STAFF REPORT

THE CORPORATION OF THE TOWN OF COBOURG

Subject/Title: **Roof Replacement – 212 King Street West – Marie Dressler House (Town of Cobourg)**

To review and provide a recommendation regarding Heritage Permit Application HP-2021-009 for a new roof at 212 King Street West in the West Heritage Conservation District.

Figure 12: 212 King St. W (Dressler House) roof plan – only highlighted areas are to be replaced. Areas B.1 and B.2 have already been replaced with a composite polymer shake style material (see Figure 17).

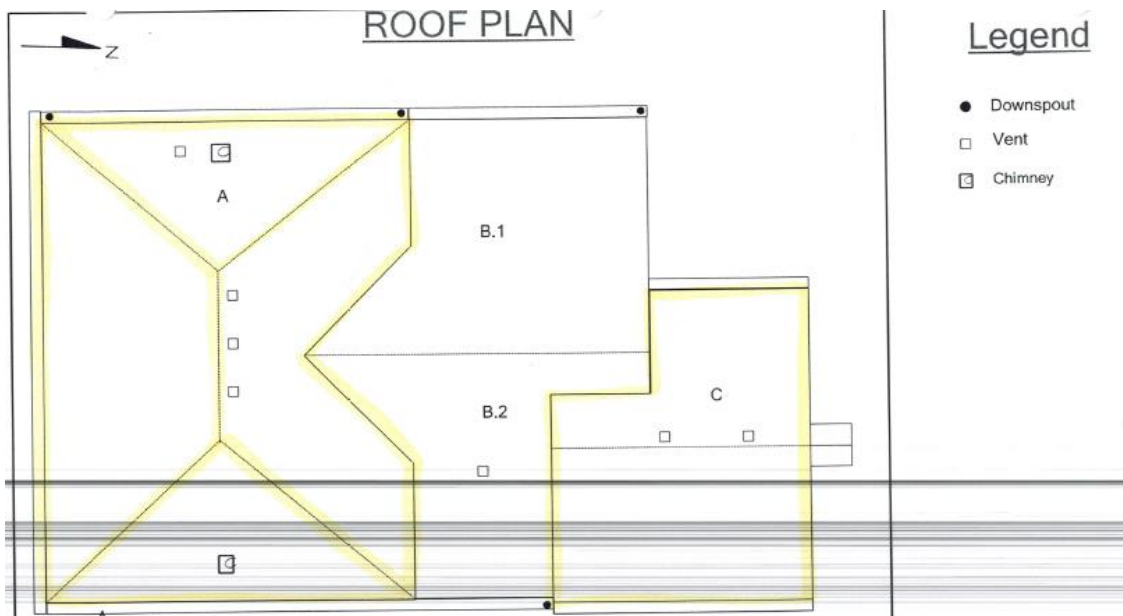
The Town of Cobourg is proposing to replace the current ageing cedar shake roofing system that exists on the front and rear sections of Dressler House as it leaking into the attic (see Figure 12- roof plan below and Figures 13-16). Presently, the Town is proposing a product called "Presidential Shake" which is a fiberglass shingle with the colour to be "weathered wood" (see Figure 17). The new fiberglass shingle is only to replace the existing deteriorated cedar shake shingles on the front primary building and the rear addition (Figure 12). The central portion of the building is currently sheathed with a composite polymer shake material design (see Figure 17). Over the years, it appears that the roofing material on the building has been altered a number of times, including what appears to have been slate, asphalt shingle and cedar wood shake.

While fiberglass shingles are considered a composite roof material, and in shake form could be an appropriate replacement product for Dressler House, Heritage and Planning staff do not recommend having two substantially different roofing materials or designs/textures on a heritage structure (fiberglass and polymer shake). Accordingly, it is recommended that a product similar in design, texture, composition and colour as the existing composite polymer shake product be installed to ensure consistency and uniformity with the balance of the building.

It should be noted that the composite polymer shake on the central portion of the existing Dressler House roof that was installed a number of years ago is no longer available. It is the recommendation of staff that a Davinci composite polymer shake product (or equivalent) be implemented in the colour "Chesapeake" as this appears to be the closest matching design and colour to the existing composite roofing material (see Figures 17-18). Additionally, the roofing contractor has indicated that

In summary, Heritage and Planning staff does not recommend using the proposed fibreglass shingle product to replace the existing deteriorating cedar shakes on the front and rear sections of the building, but rather recommends using a composite polymer shake material by Davinci (or equivalent) in “Chesapeake” colour to more closely match the existing polymer shake currently in use on the central section of the building. Staff’s recommended approach for this polymer shake has been evaluated against the West HCD Plan, specifically the policy relating to roofs (4.2), and it is our opinion that the new roof on the front and rear sections of the building (change from cedar wood shake to a polymer shake) is an acceptable, complementary alteration and would be consistent with the central section that already exists today. The roofline and chimneys, and other defined heritage attributes, are not proposed to be changed as a result of this alteration. The applicant has retained Ontario Roofing as the contractor to undertake the proposed alteration.
